Stag's Field

Rezoning from AG to R-1 & RP-4 & Preliminary Development Plan

PL2020-210

September 24, 2020

Requested Modifications

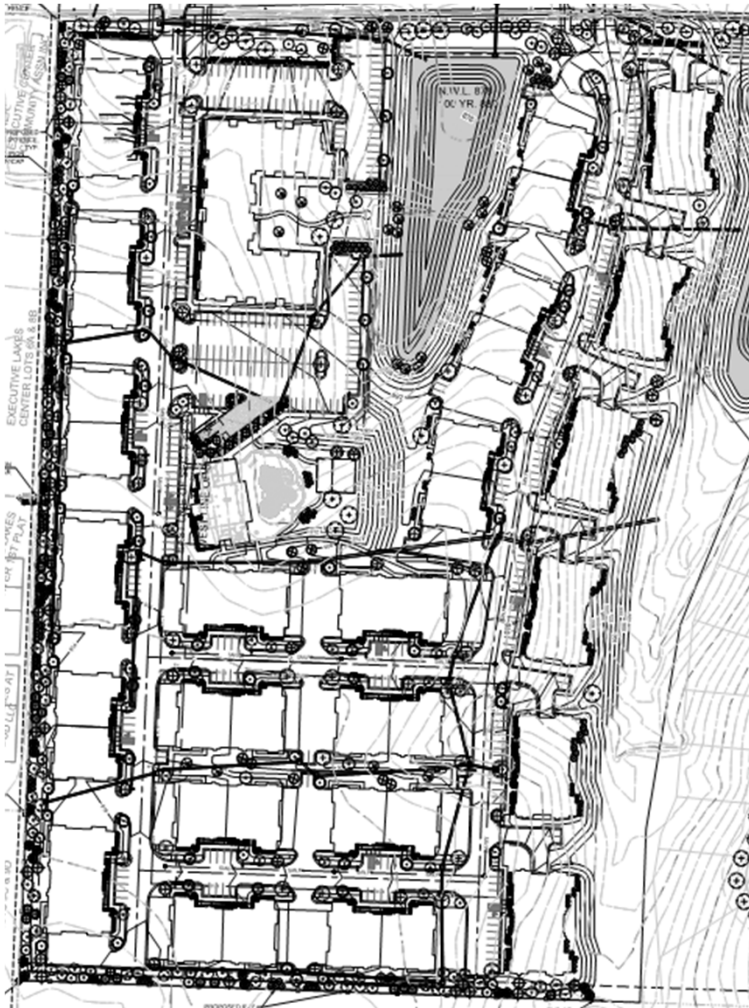
Density and Minimum Lot Size. Modifications requested.

- Required – 12 dwelling units per acre maximum in the RP-4 district; and minimum 3,500 sq. ft. lot size per dwelling unit
- Proposed – 13.7 dwelling units per acre; and 3,200 sq. ft. lot size per dwelling unit

Landscaping, Caliper Size. Modification requested.

- Required – Section 8.750 of the UDO requires a minimum of 3-inch caliper, measured at a point 6 inches above the ground or top of the root ball, at planting.
- Proposed – The applicant has requested two modifications to this requirement: (1) a minimum 2.5-inch caliper for shade trees; and (2) a minimum 2-inch caliper for ornamental trees.

Landscaping, Height. Modification requested.

- Required – Section 8.750 of the UDO requires a minimum height of 8 feet at planting for evergreen trees.
- Proposed – The applicant has requested a modification of 3' to allow for a minimum height of 5' for evergreen trees.

1. A modification shall be granted to the maximum density of 12 units per acre in the RP-4 district, to allow a density of 13.7 units per acre in the RP-4 district.

2. A modification shall be granted to the minimum lot size of 3,500 sq. ft. per dwelling unit in the RP-4 district, to allow a minimum lot size of 3,200 sq. ft. per dwelling unit in the RP-4 district.

3. A modification shall be granted to the minimum 3-inch caliper size for deciduous trees, to allow 2.5-inch deciduous shade trees and 2-inch deciduous ornamental trees.

4. A modification shall be granted to the minimum 8-foot height for evergreen trees, to allow 6-foot evergreen trees.
5. A modification shall be granted to the requirement that the fence in a high-impact landscape buffer be located 10 feet from the property line (i.e., centered within the 20-foot landscape buffer), to allow the fence to be located on the property line.

High-impact Landscape Buffer – fence location. Modification requested.

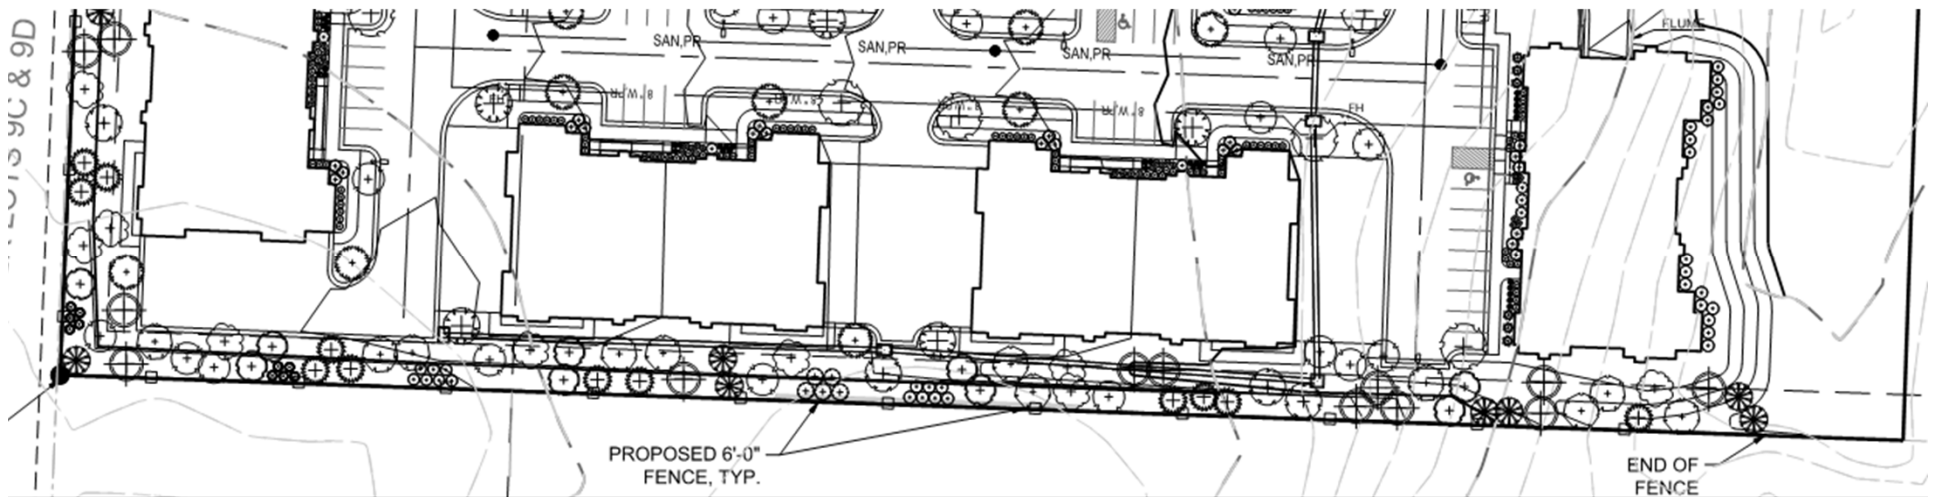
- Required – The 6' fence or wall is required to be centered within the 20'-wide high-impact landscape buffer located along the property line.
- Proposed – The 6' fence will be located on the property line.
